## **EXPERT OPINION – NARRABRI UNDERGROUND MINE STAGE 3 EXTENSION PROJECT (SSD 10269)**

**Dr Steven Pells**

This advice has been prepared in response to a brief (the Brief) from Environmental Defenders Office (EDO) dated 28 January 2022 (ref: S2602). The Brief requests review of various documents in relation to the Narrabri Underground Mine Stage 3 Extension Project (Project) and to provide a report which addresses the following issues in regard to any groundwater and/or surface water impacts arising as a result of the Project:

Figure 2 – Overview of regional geology with the approved mine and the Project and showing interpreted geological section as presented in the EIS (note: colours used in upper figure differ from those used in lower figure)

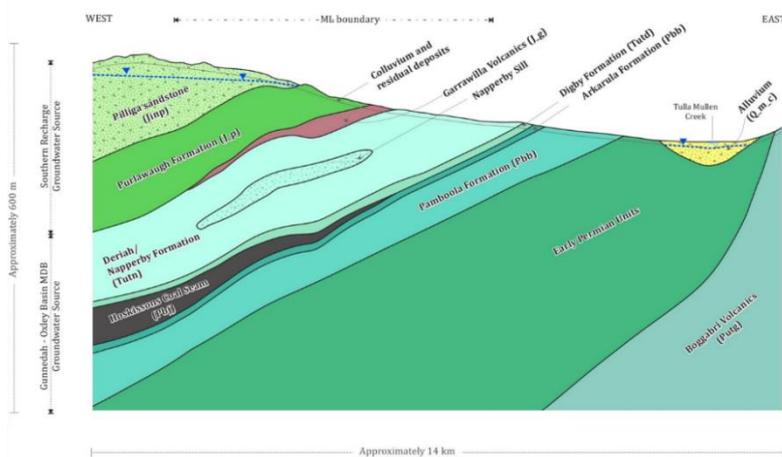
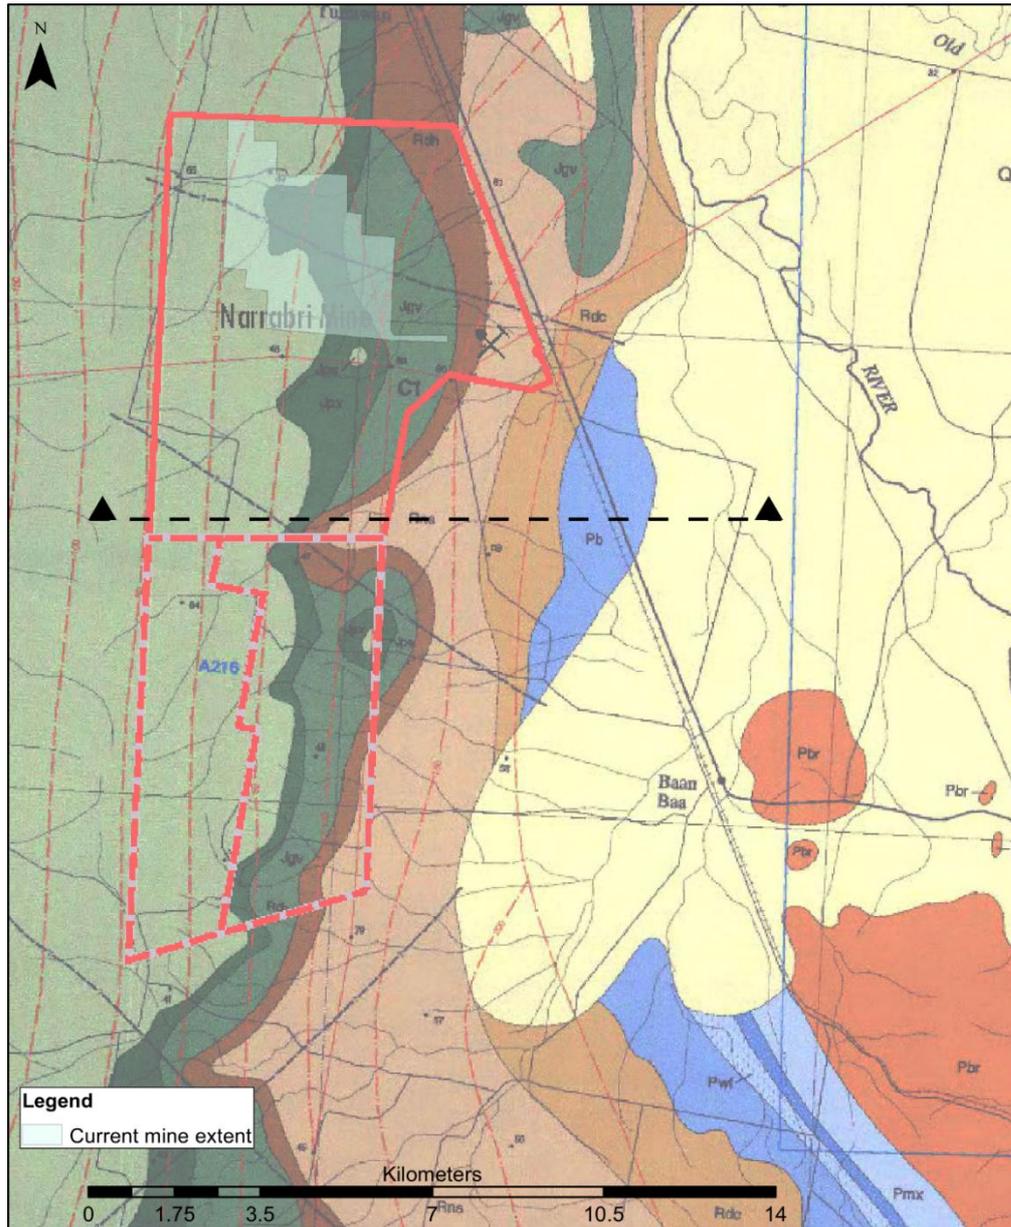
It was not possible in the scope of the present advice, to review in detail the interpreted geology shown in the cross section in Figure 2 (i.e. against bore data). It is noted that:

1. The exaggerated vertical scale in the conceptual cross-section visually over-emphasises the dip of the strata.
2. In my experience, hydrogeologists tend to expect flow to follow along geological sequences with flow between sequences seen as a secondary process or even an aberration requiring special labelling as “connectivity” or similar, whereas in reality, water moves from high potential to low potential with no regard to such simplifications of geology as imposed by humans. Such a conceptualisation, if adopted in the modelling, would diminish representation of connection between mining in the Hoskissons seam and the alluvium.
3. The extent of alluvium is greatly under-represented in the conceptual cross-section.

**Figure 5 – Locations of groundwater monitoring listed in the EIS**

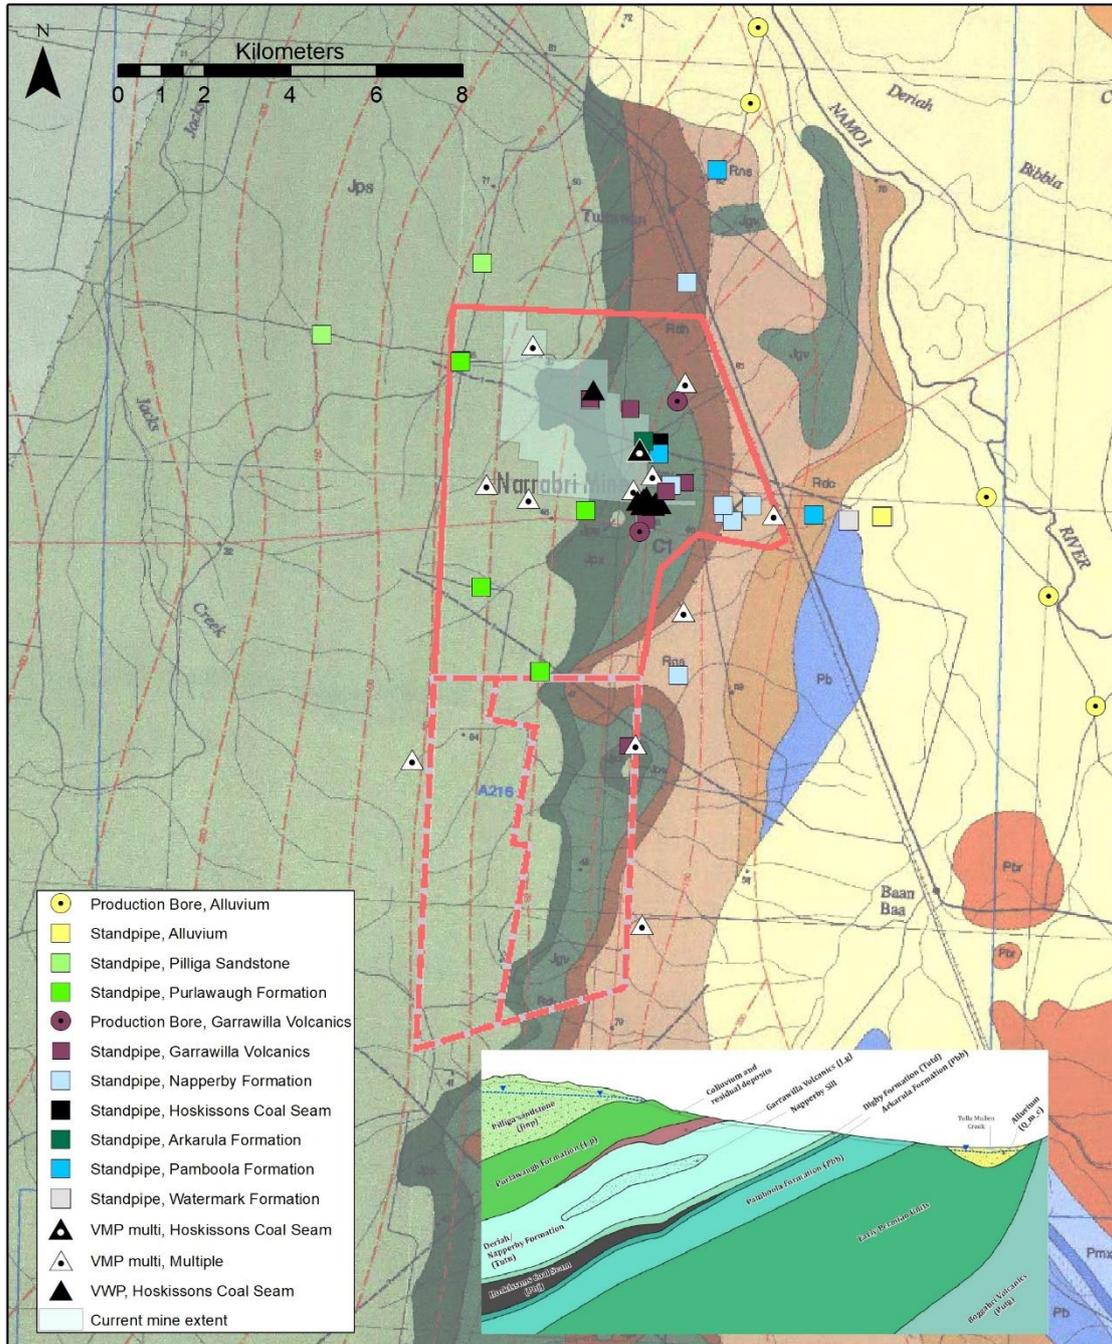
It can be seen in Figure 5 that few wells exist to characterise baseline conditions and then monitor impacts from the Project. In my opinion there are insufficient monitoring locations to support obtaining “detailed baseline data” as required by Section B35 (iv) of the Draft Conditions of Consent for the Project. It is also of concern that monitoring of previous bores has been unreliable and has ceased in many locations. The Draft Conditions of Consent for the Project require what I consider to be a reasonable ongoing monitoring requirements, but are unclear what consequences for non-compliance are so as to enforce ongoing and reliable monitoring of groundwater in accordance with the conditions

If the Project is approved, the existing VWPs around the Project perimeter will be invaluable to monitor mining effects and should be maintained and be replaced if broken.

Figure 7 – Observation of groundwater monitoring in wells commencing prior to 2012 (dd=drawdown; disc.=discontinued)

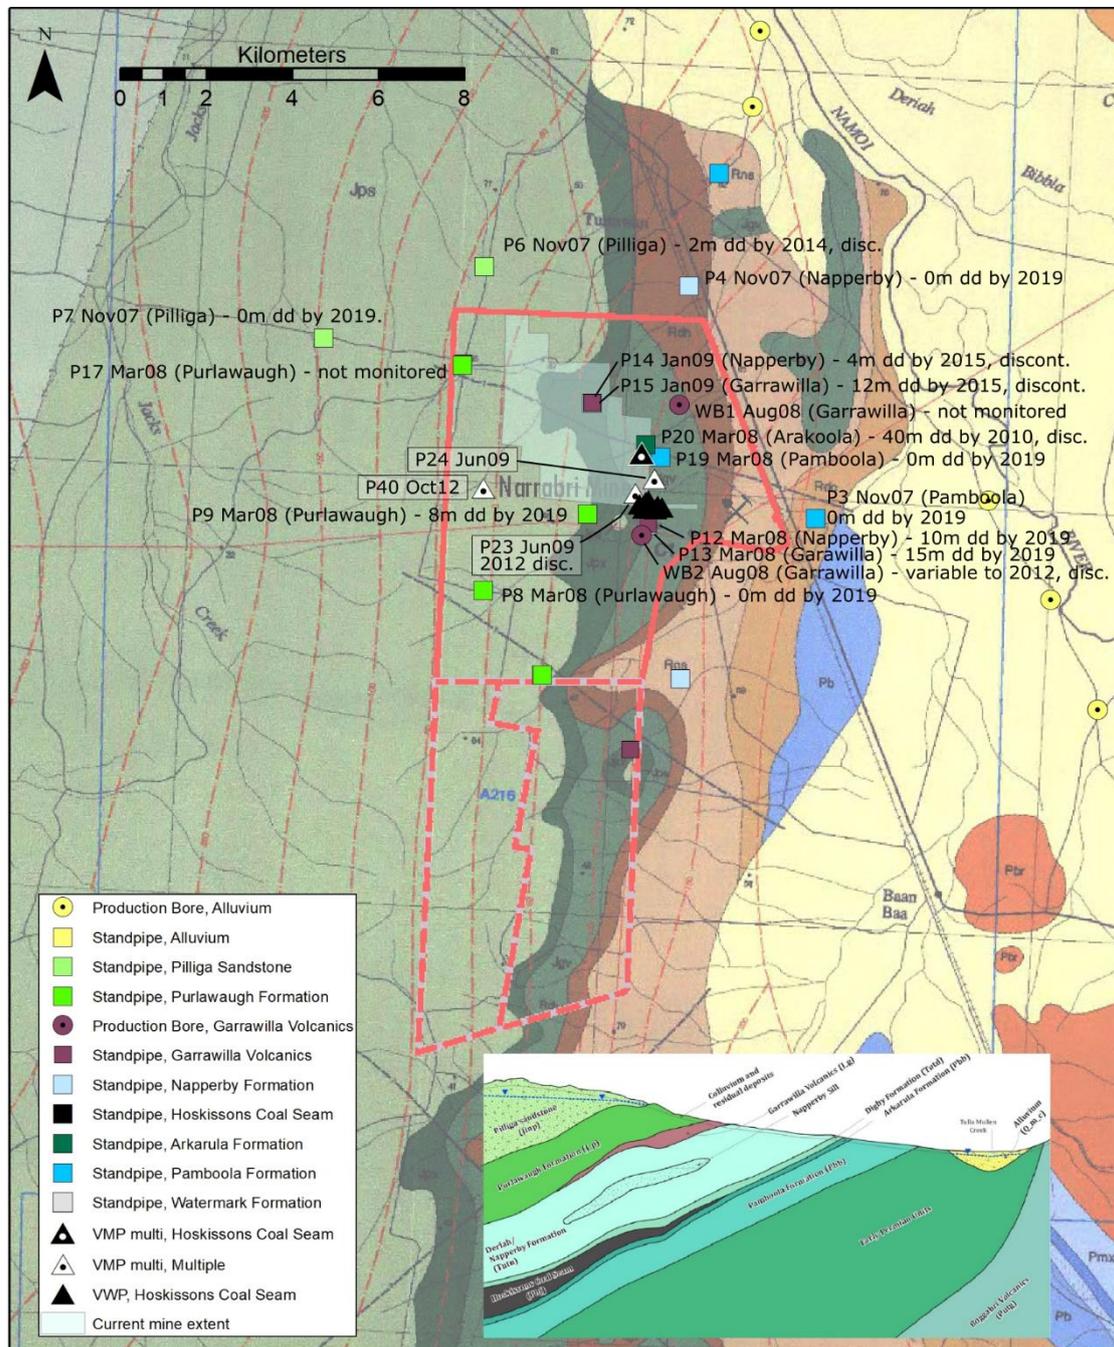
Drawdown is observed in most wells and VWP data show that conditions are approximately hydrostatic prior to mining, with development of a flow toward the coal seam from above and upward from below once mining progresses - that is typically observed in longwall mining. Unfortunately monitoring in many wells has been either absent or discontinued. Only a single well (P2) appears to continue monitoring within the Pilliga Sandstone. VWP data for P23 is not available for the last 10 years. There is no data after 2019 presented at any of the monitoring points.

**Figure 9 – Hydraulic conductivity data referenced in the EIS Groundwater study**

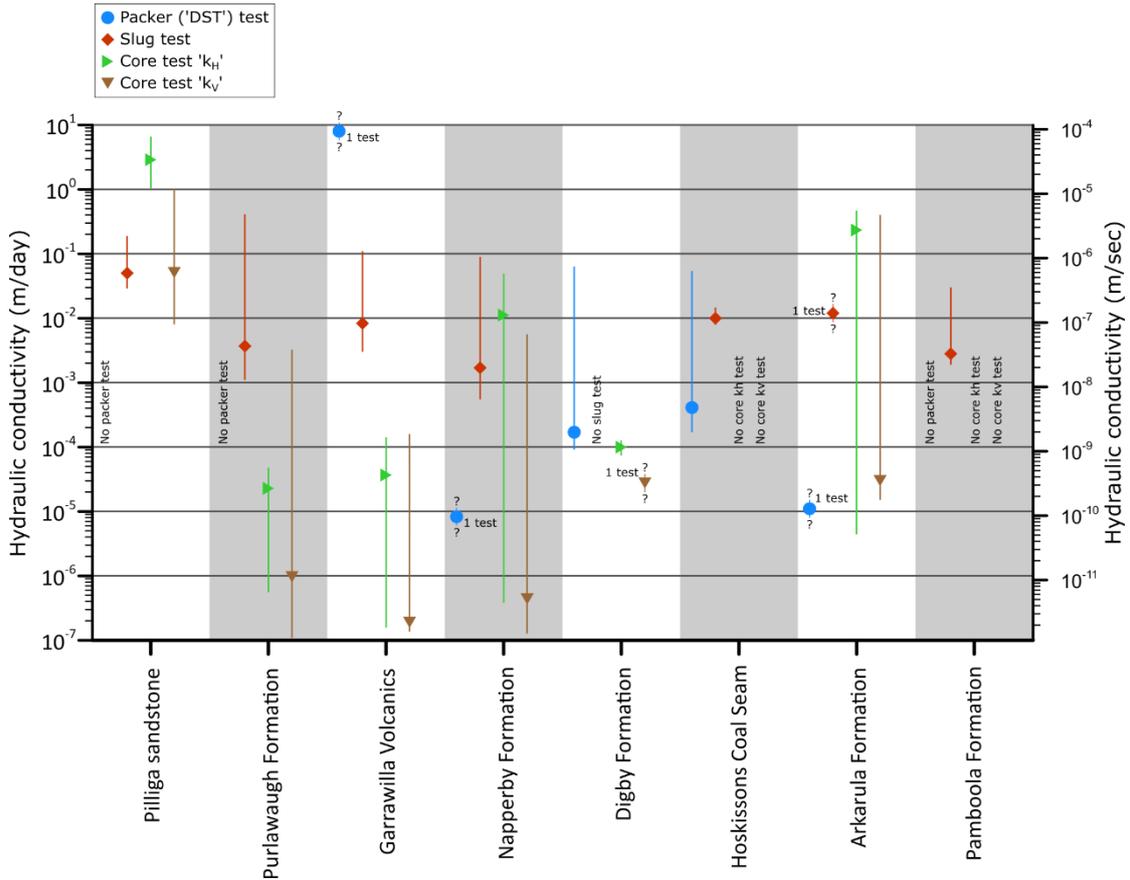
The groundwater studies for the Project compiled previously undertaken field data. The data that was considered came from packer tests, slug tests and laboratory core tests. These data are presented in Figure 9. The following comments are made:

1. No pumping test data was included.
2. Packer (DST) tests typically cannot measure hydraulic conductivity below  $1 \times 10^{-7}$  m/s – perhaps extending to  $1 \times 10^{-8}$  m/s with special equipment. Tests presented in the EIS reported packer test measurements below this, and even down to  $10 \times 10^{-10}$  m/s. This appears to be implausible and suggests error in interpretation and / or units. I was unable to access the source data for these tests (eg cited as Sigra, 2006 in the EIS) to review this.

3. Laboratory tests on core samples typically report significantly lower hydraulic conductivity values (with some instances of very high values) - this is consistent with the commentary in Section 2.2.1 above.

4. It is unclear how laboratory tests were able to be demarcated into measurements of hydraulic conductivity in the horizontal direction ( $k_H$ ) and in the vertical direction ( $k_V$ ) (it is difficult to obtain horizontal core samples, for example). I was unable to access the source data for these tests (eg cited as Weatherford, 2009 and Core Laboratories Australia, 2018 in the EIS) to review this.

With reference to my comments in Section 2.2.1 above, it is evident that the dataset of field testing is poor, because of the lack of pumping tests, which I consider to be the most appropriate, and because there appears to be an issue with the undertaking or interpretation of the packer tests. As shown below, groundwater modelling then relies heavily upon laboratory tests, which I do not consider to be appropriate as described above. The consequence of this is a limited certainty around suitable hydraulic conductivity (and other) values. The basis of science is testable hypotheses, and there is a limited basis to scientifically defend the values adopted in modelling against test.

Figure 13 – Conceptual model (above) versus groundwater model (below) (additional annotations shown)

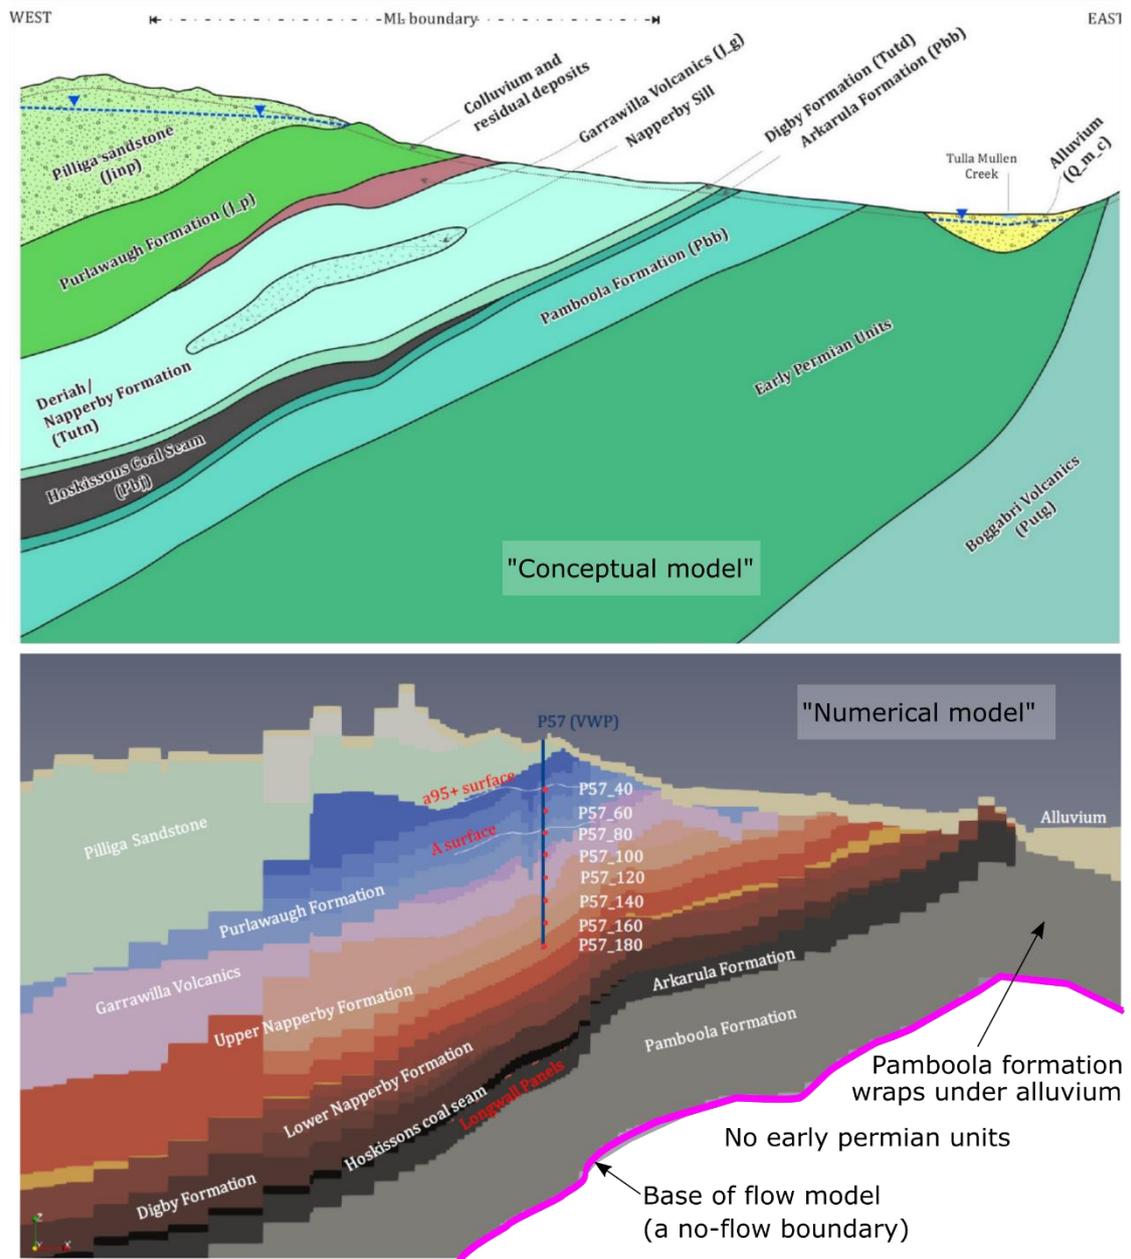
The groundwater study in the EIS presents the cross section reproduced in Figure 2 above as the ‘conceptual model’. However, the groundwater modelling represents geology differently to this concept. A cross section from the numerical model is presented adjacent to the conceptual model in Figure 13. The groundwater model appears to conform more to the conceptual model in Figure 14, as adopted in previous groundwater modelling. Notably:

1. The groundwater model does not include the geological layers below the Pamboola Formation. As such, there is a no-flow boundary along the base of the Pamboola Formation.
2. The Pamboola Formation is represented as folding under the alluvium, effectively cupping the alluvium.

This conceptual model limits the possible impact of mining on the alluvium aquifer as an *a priori* assumption, because it wraps the alluvium within the Pamboola Formation,

and the no-flow boundary under the Pamboola limits the connection with the alluvium. No reasoning for this representation is given in the EIS, and the geological basis for representation of the Pamboola Formation in this manner is unclear.

**Figure 15 – Hydraulic conductivity values used in the EIS, presented alongside tested values**

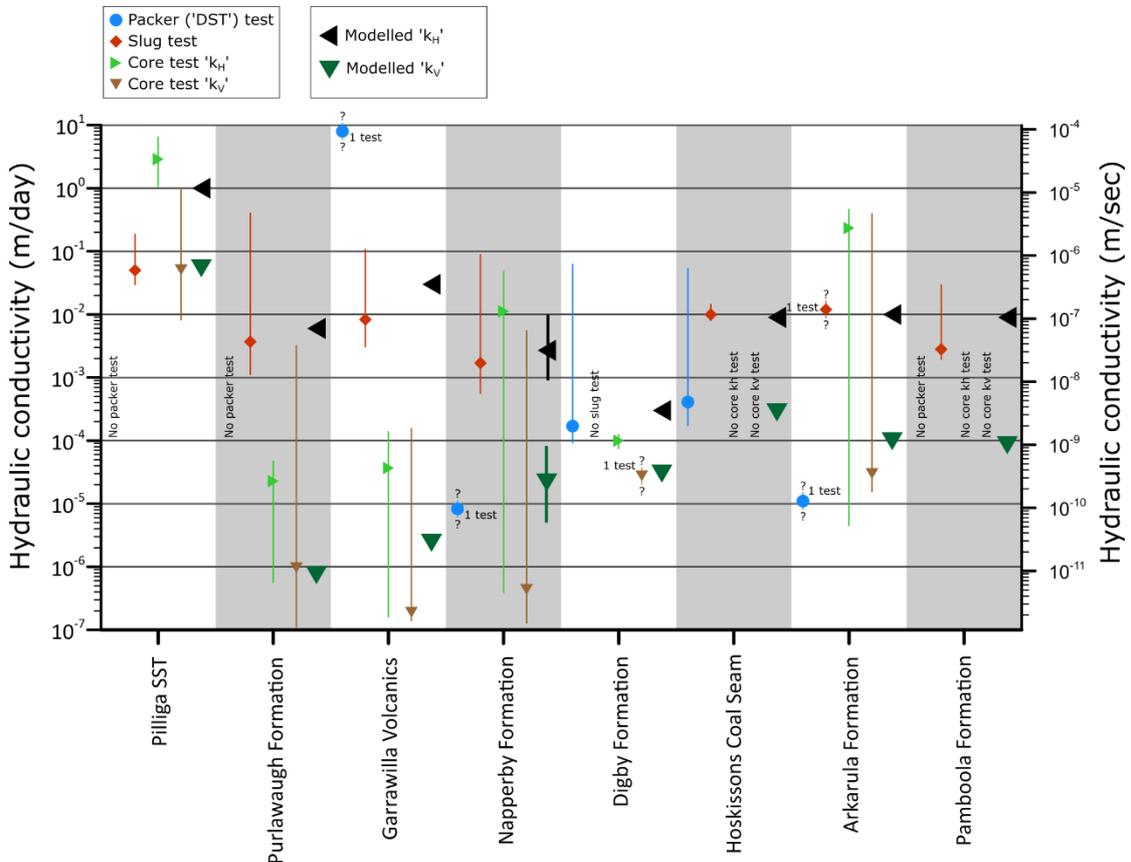
The adopted values for horizontal hydraulic conductivity ' $k_H$ ' typically approximate the slug test data. Of the available data, this is probably the most reasonable, as the packer test data appears to be erroneous (see Section 2.2.2) and laboratory core data is not a reliable guide to regional groundwater models (Section 2.2.1). However, it is disappointing that such a significant groundwater model should be underpinned by only this relatively rudimentary test data, and a project of such scale should be supported by quality pump testing data and a large suite of reliable packer (DST) tests.

The adopted values for vertical hydraulic conductivity ' $k_V$ ' are very low. The groundwater study for the EIS makes an argument that ' $k_V$ ' values are proportionally lower than ' $k_H$ ' by the same ratio that exists "*between the median value from slug or DST tests and the median vertical hydraulic conductivity value from core tests*" (pg 63). I do not consider this to be a robust line of reasoning given the significant differences in test characteristics. For example, the ratio between horizontal laboratory core tests and field tests (i.e. *in the same direction*) is similarly low. It is also creating a mathematical reliance upon a small dataset of highly variable data sources. The end result is that ' $k_V$ ' is taken at a small fraction of ' $k_H$ ' – up to 10,000 times less, and this results in very low ' $k_V$ ' values. In my opinion it is untenable to adopt such extreme ratios, especially in the absence of clear measurements to support it.

These low vertical hydraulic conductivity ' $k_V$ ' would have the effect of minimising predicted effects of the mine to the upper layers, such as the Pilliga Sandstone. It would also minimise downward drainage from the Namoi Alluvium.

Given the significance of these values on the predicted effects, my view is that:

1. Large scale pumping tests are warranted to provide more reliable estimates of ' $k_H$ '. Well planned pumping tests can also allow estimation of ' $k_V$ ' values.
2. A precautionary principle should be adopted in the case of uncertainty about ' $k_V$ ' values, which would lead to adopting of more standard  $k_V/k_H$  ratios of the order of 5 to 10, rather than the speculative and uncommonly high ratios adopted of up to 10,000.
